UNITED STATES ENVIRONMENTAL PROTECTION AGENCY
REGION IX
75 Hawthorne Street
San Francisco, CA 94105

The U.S. Environmental Protection Agency has conducted an inspection of the East-Side Aquifer Treatment System (EATS) at Moffett Federal Airfield. This inspection was performed by TRC, a subcontractor to TechLaw Inc., under an EPA contract. EPA performed this inspection to assess whether the remedial action as constructed, is consistent with the Remedial Design. Results of the inspection are enclosed.

INSPECTION OF EAST-SIDE AQUIFER TREATMENT SYSTEM AT MOFFETT FEDERAL AIR FIELD, MOUNTAIN VIEW, CALIFORNIA

Photo 1. 9/8/99, 11:00 a.m. (northwest)
LGAC systems and effluent discharge piping

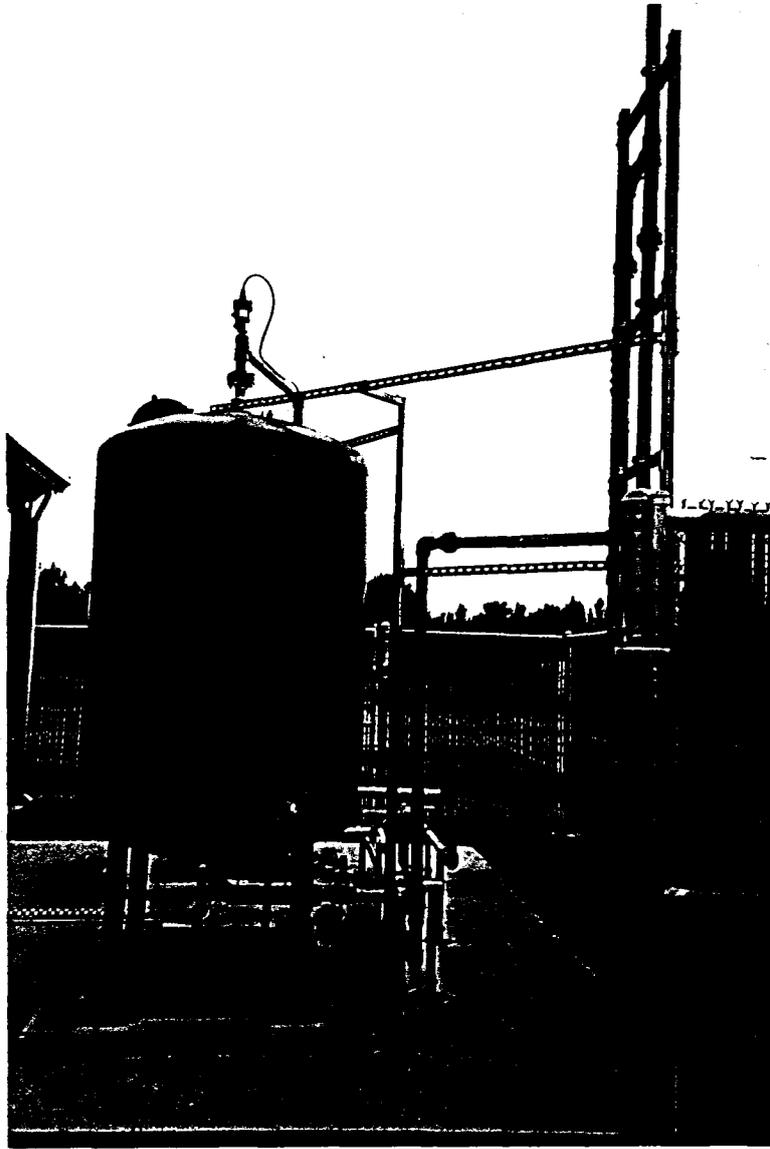
Based on the inspection, it appears that the flow rate may be exceeding the system design at some times. Once the flow rate is increased past 40 gpm., the piping at the discharge point starts leaking treated water through a raised pipe prior to discharge. Inspection of the design drawings indicates that the effluent of the LGAC is discharged to the storm drain through a 2-inch PVC pipe which is elevated 1'-8" above the LGAC canister influent line, bent through one three way "T" and one 90-degree elbow and discharged. The top side of the "T" is a 2-foot pipe that is open to the atmosphere (Photos 1 and 2). As the flow rate is increased to above 40 gpm., some of the effluent is discharged through the open pipe. Please explain this phenomenon and how it can be addressed.
